ADDENDUM TO BID DOCUMENTS

PALO VERDE COLLEGE PROJECT BID NO. 2018-01

PVC COLLEGE SERVICES BUILDING RENOVATIONS

ADDENDUM #2

NOTES, **ABBREVIATIONS** AND ACESSIBILITY

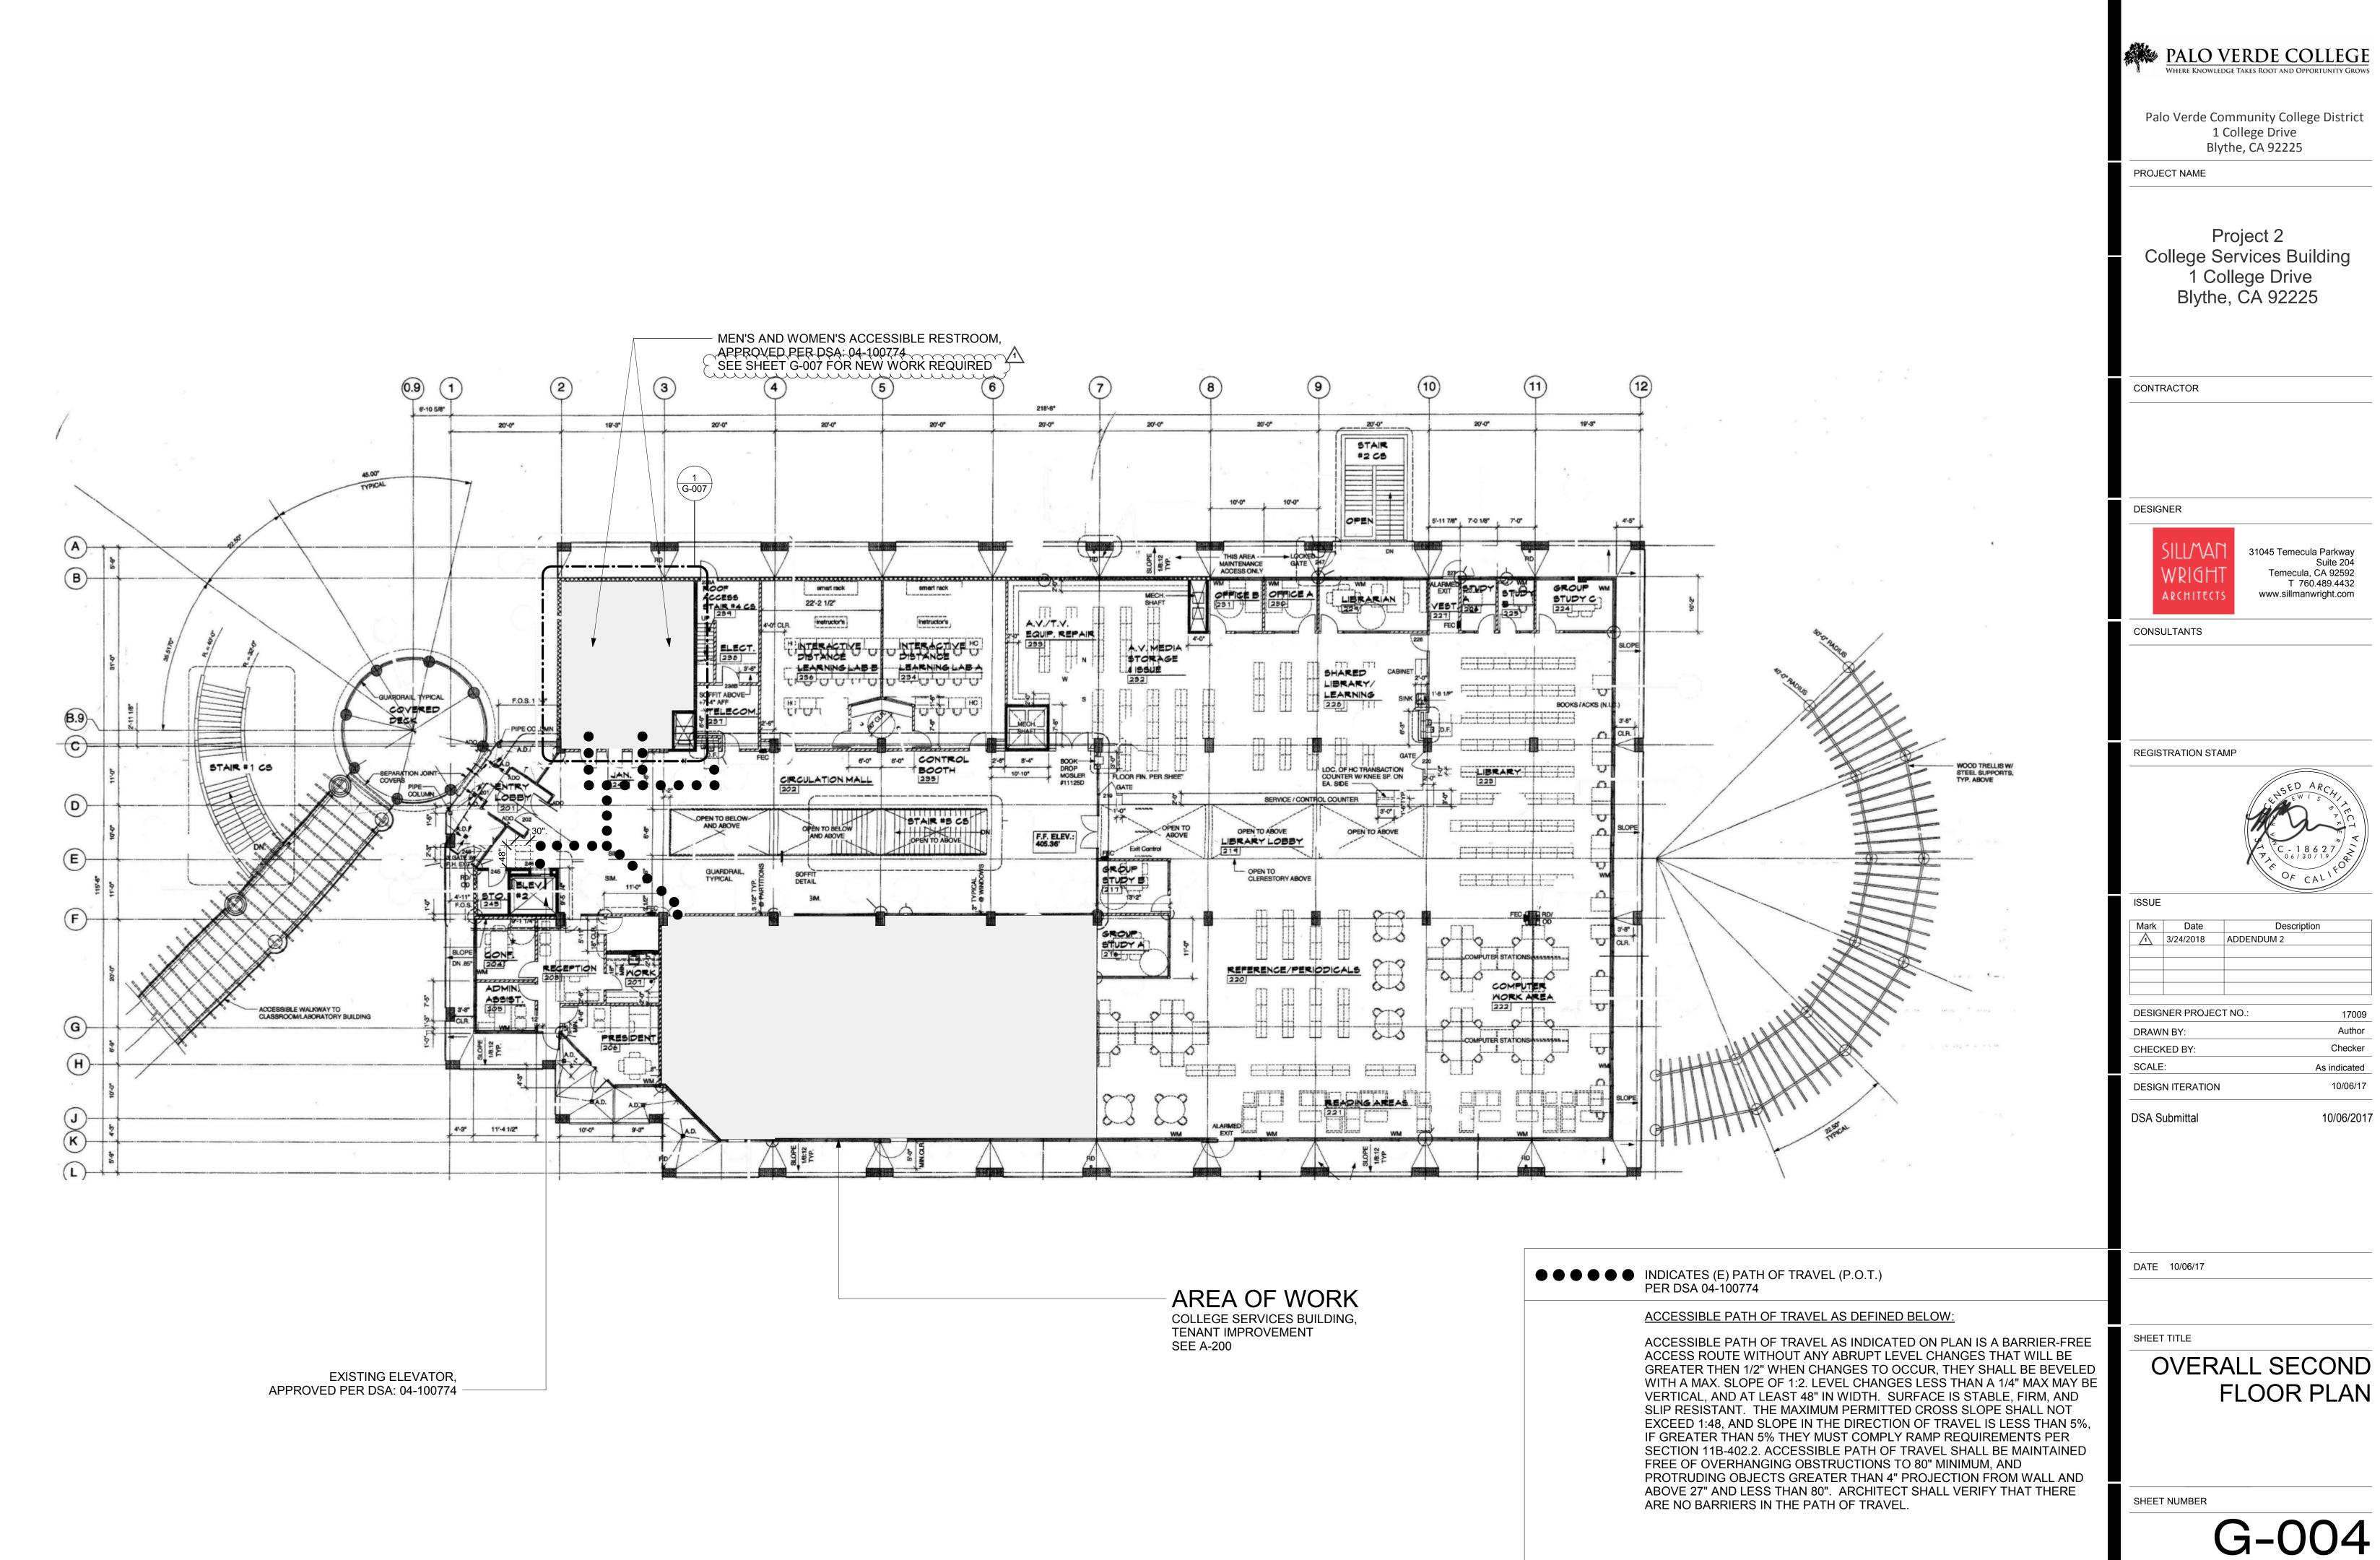
| Note: All changes to the drawings have been clouded and identified with a Delta 1 revision | | | | | |
|--|------------|--|--|--|--|
| Item 1: Reference She | eet G-002: | Redundant GENERAL NOTES 33-52, have been removed. Note 17 sentence overlap corrected | | | |

SCHEDULES & INTERIOR ELEVATIONS

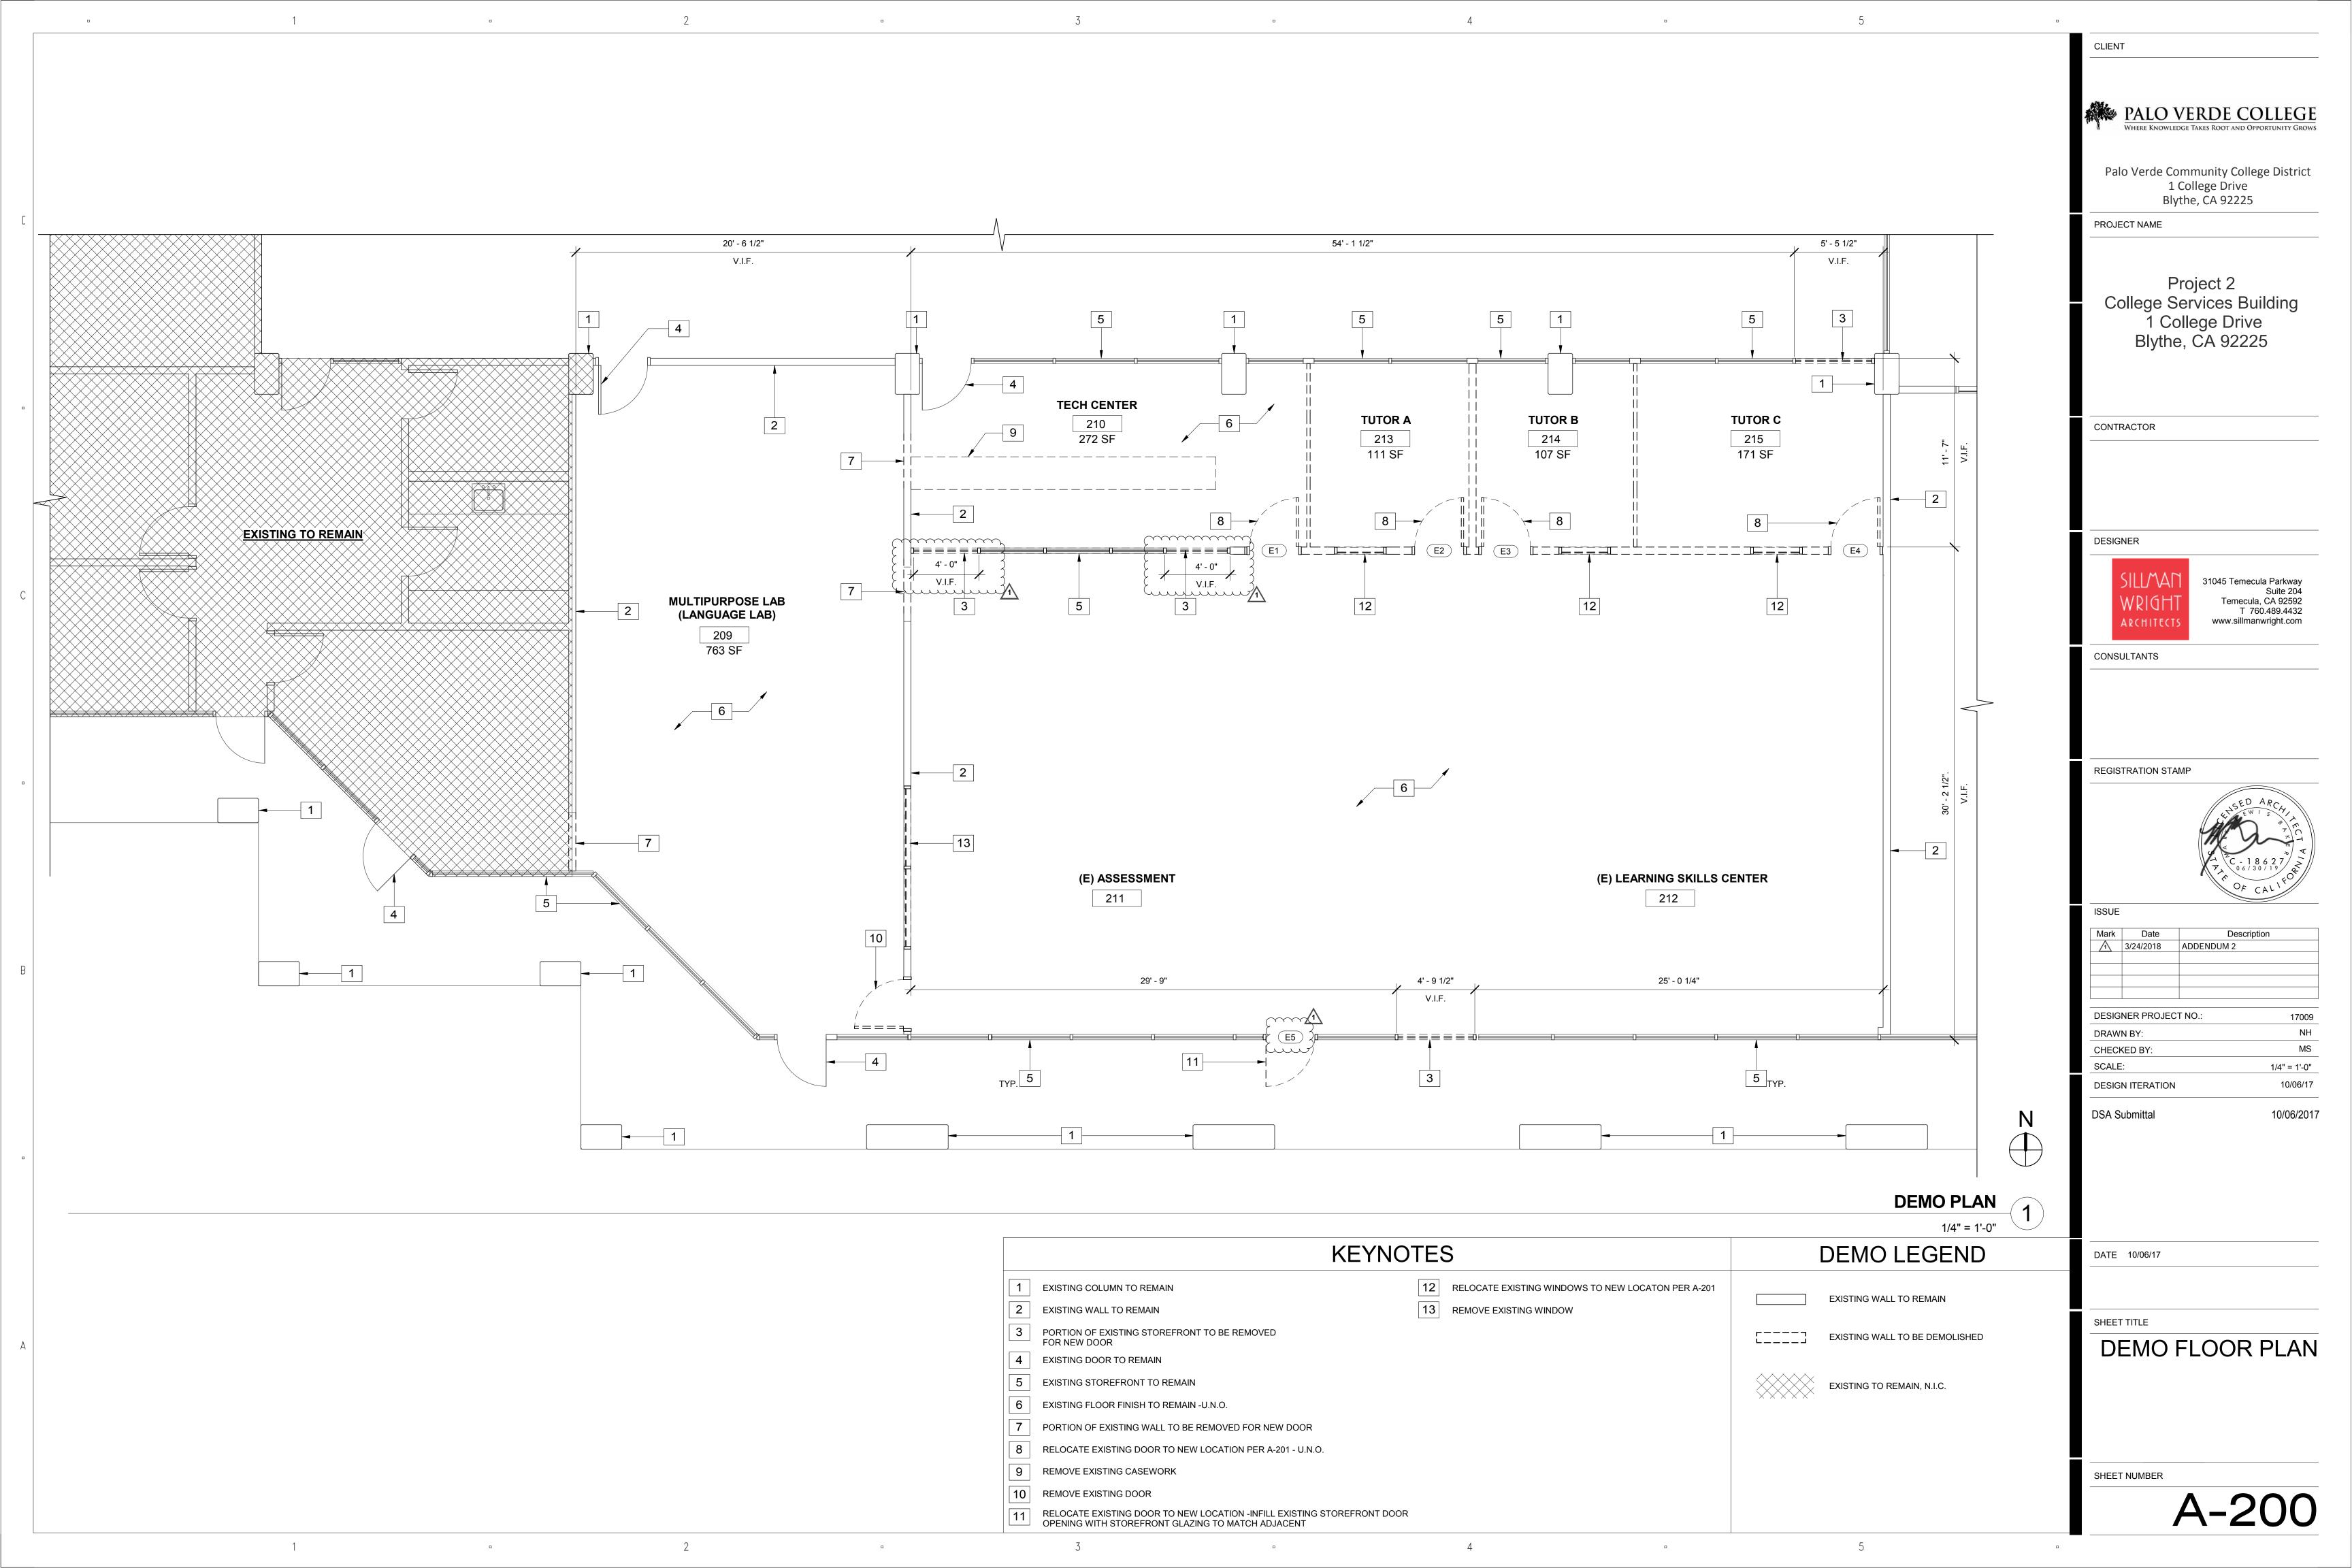
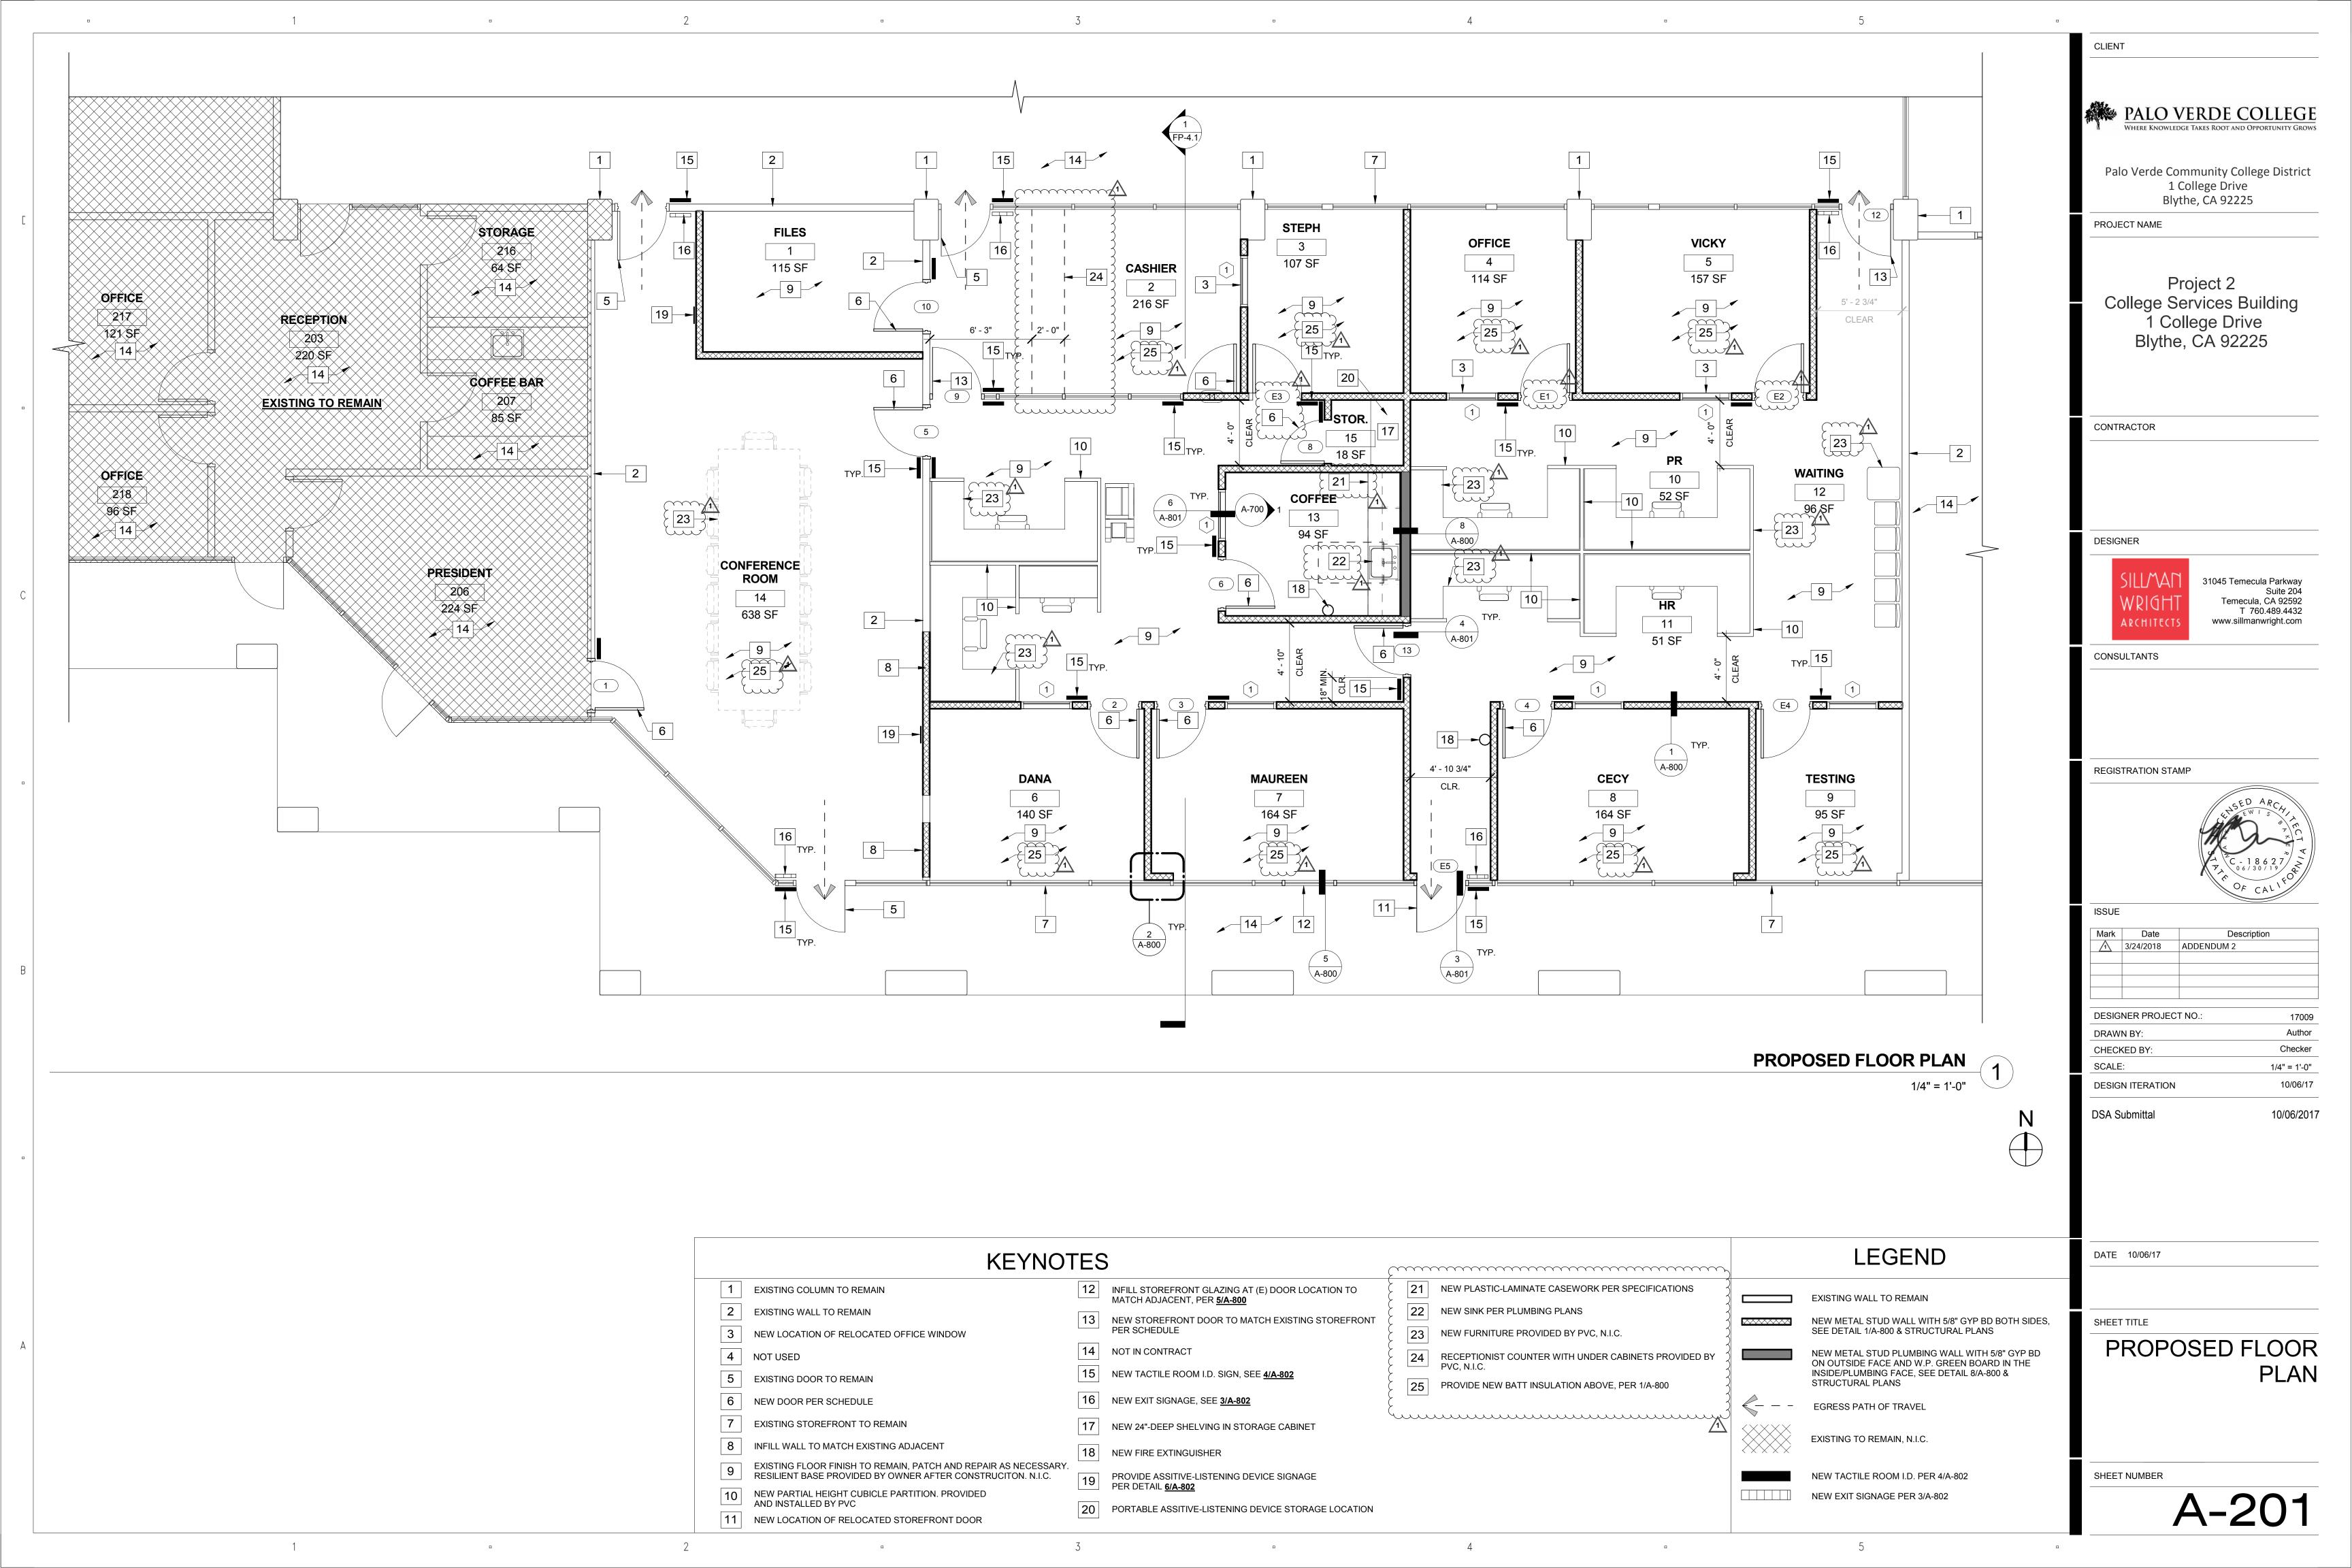
Item 10: Reference Sheet A-700: DOOR SCHEDULE: Door #11, Elevation Type "D" added

Door Elevation Type "B" has been modified to show transom and

side lite

Keynote 2 revised
